# Re. 2BB-MAE---- Madrid Advanced Exploration Program Type B Water Licence Application

Subject: Hope Bay Project: Madrid North Bulk Sample Surface Infrastructure

# Engineering Drawings for the Madrid North Bulk Sample Surface Infrastructure, Hope Bay Project, Nunavut, Canada

Subject: Madrid North Advanced Exploration Surface Infrastructure Assessment

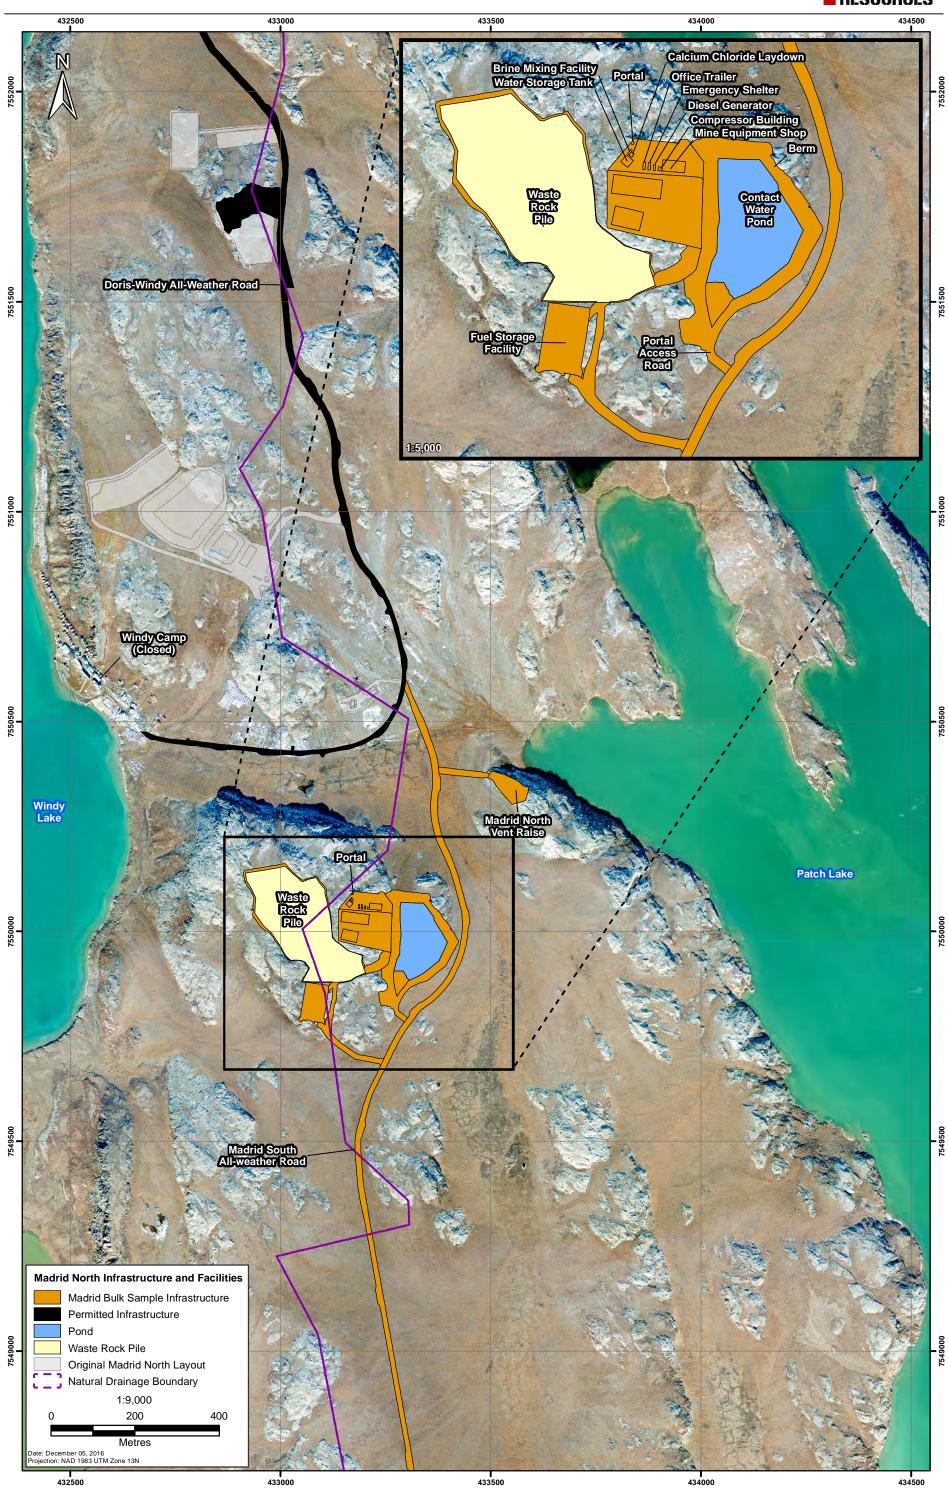
Figure 1 of this memorandum shows the revised Madrid North layout, approximately 1 km south of the original location. The area of the revised Madrid North layout is 69,810 m²; a 25% decrease in the total footprint of the original Madrid North layout.
